RC1.1 In the paper, hydrological problems rather than soil properties are discussed.

RC1.2 Unfortunately, the paper is not generally well written, organized and balanced. The introduction is very short and quite approximate. A real state of the art is completely missing. Introduction should more concisely lead to the objectives of the work. Usually, a general rationale is needed. What is the purpose of the study?

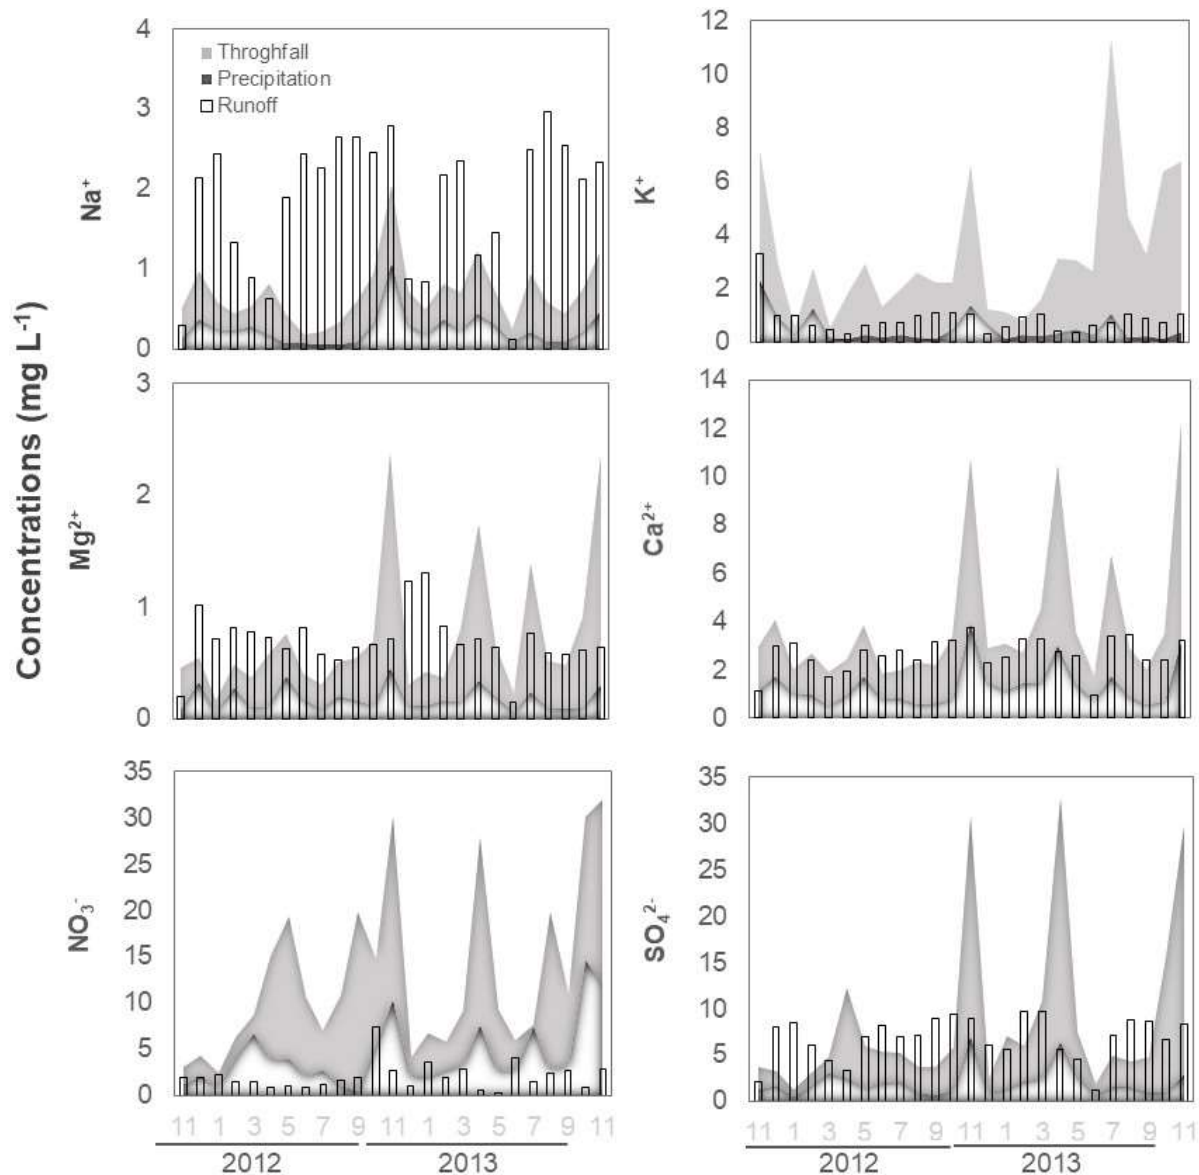
RC1.26 Figure 2 is unreadable due to unclear crosshatch. Does it present data obtained by authors?

As per reviewer request the crosshatch has been removed from the revised version of Figure 2 thus making it clearer. Figure 2 is background information and in consequence is first called in section 2, *Study Site and Background Information*.
